BROWNS FERRY NUCLEAR PLANT, UNIT NO. 1

Amendment No. 64
License No. DPR-33

Amendment No. 60
License No. DPR-52

SAFETY EVALUATION BY THE OFFICE OF NUCLEAR REACTOR REGULATION
SUPPORTING AMENDMENT NO. 64 TO FACILITY OPERATING LICENSE NO. DPR-33
AMENDMENT NO. 60 TO FACILITY OPERATING LICENSE NO. DPR-52
TENNESSEE VALLEY AUTHORITY
BROWNS FERRY NUCLEAR PLANT, UNIT NOS. 1 AND 2
DOCKET NOS. 50-259 AND 50-260

Residual Heat Removal System, Unit
Cross Connections and Standby Coolant Supply

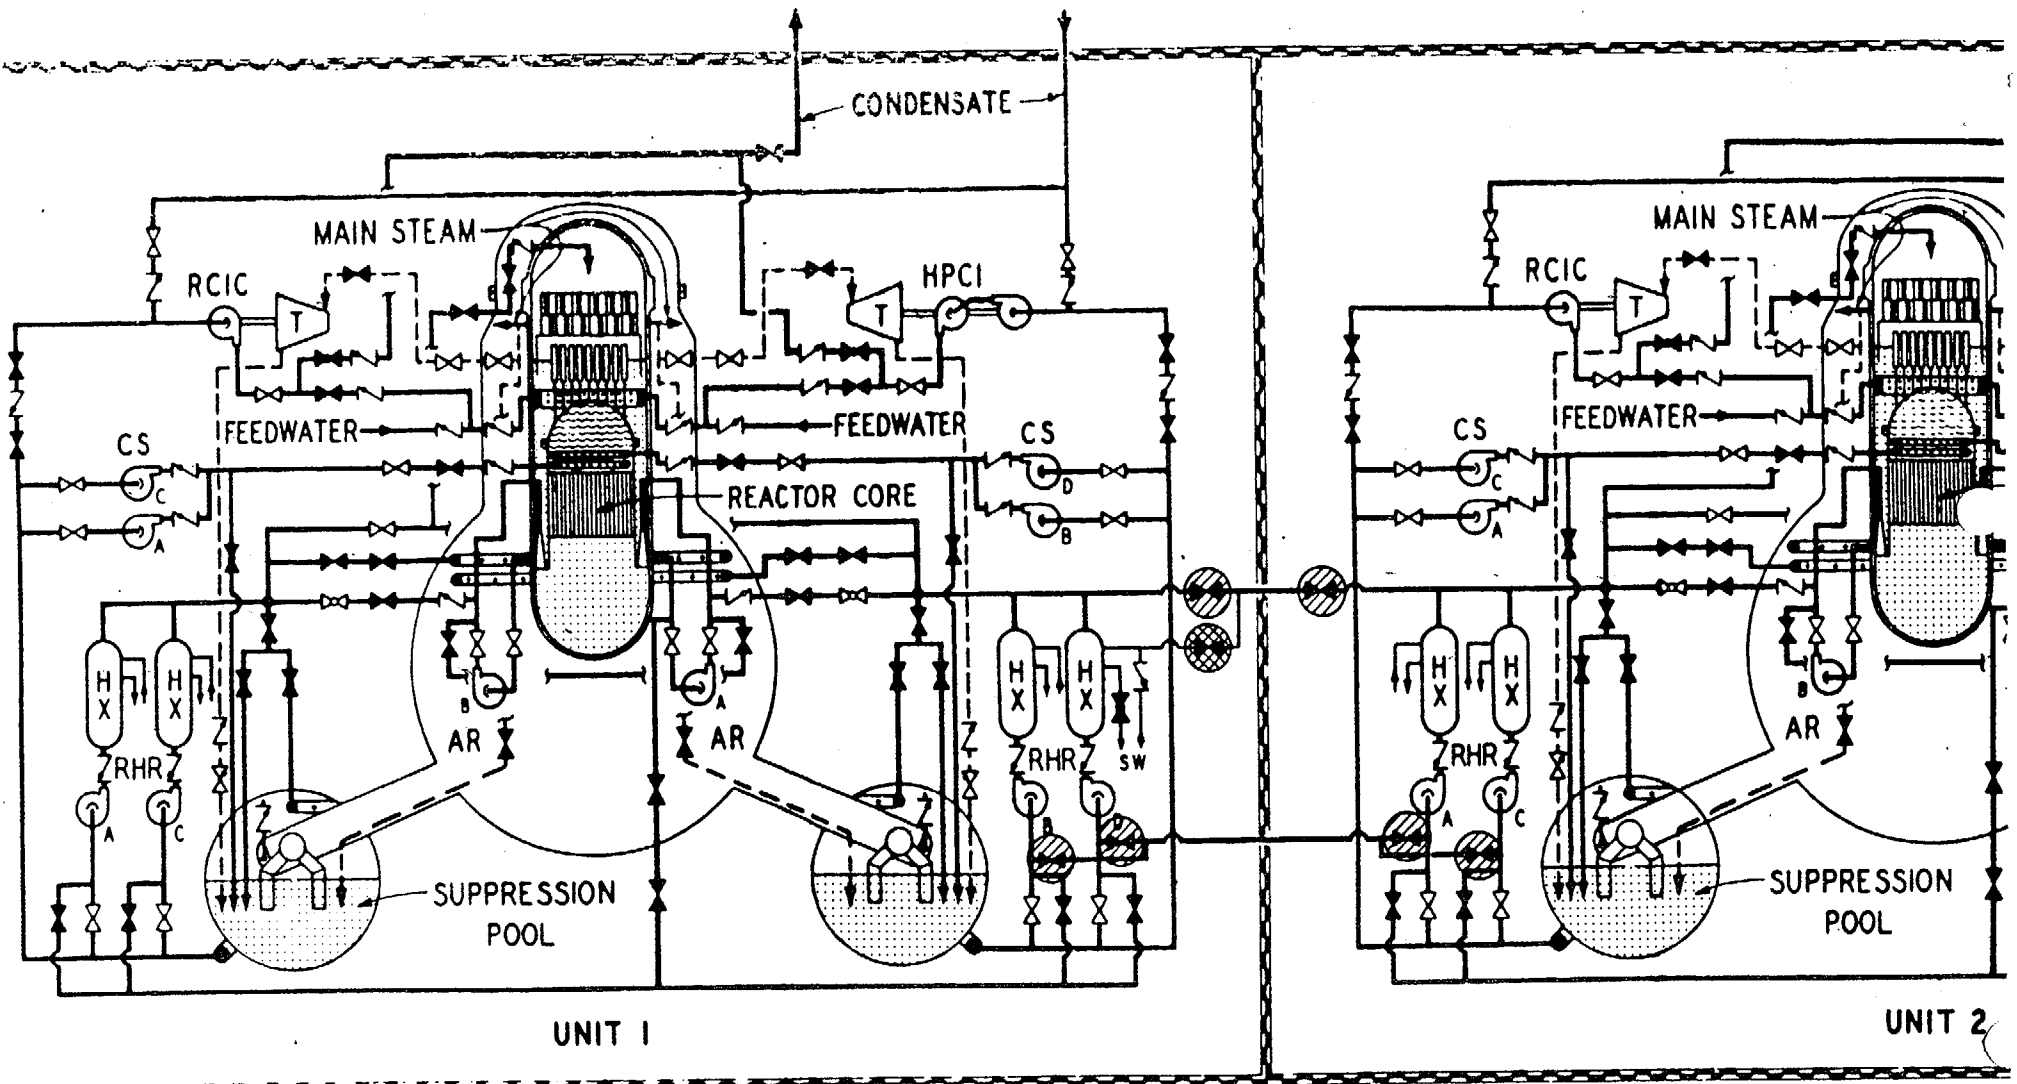
As noted in the previous safety evaluation, the RHR pump suction and heat exchanger discharge lines of one loop in Unit 1 are cross-connected to the pump suction and heat exchanger discharge lines of one RHR loop in Unit 2. Units 2 and 3 systems are cross-connected in a similar manner. This arrangement is shown in the attached figure for Units 1 and 2. The cross-connection valves are those in the lined or cross-hatched circles. The cross-hatched valve permits RHRSW (river water) from the IDRHR heat exchanger to be added to the RHR system (primary coolant) as a last-ditch emergency if all the "clean" water sources of cooling water in Units 1 and 2 have been lost (condensate, suppression pool, etc.) and the normal service water makeup in the unit in trouble is not available. The present Technical Specifications do not provide any period of time for the RHRSW cross-connection to be out of service, which in turn does not allow the associated RHR heat exchangers and RHRSW pumps to be out of service for maintenance - even though there is considerable redundancy in the RHR systems and the present Technical Specifications permit the RHR cross-flow connections to be out-of-service for up to 10 days. We conclude, as we did in Amendment No. 34, that the proposed Technical Specification change to allow a 10 day outage time for the RHRSW cross-flow connection between units is acceptable and that the overall reduction in plant safety margin is insignificant.
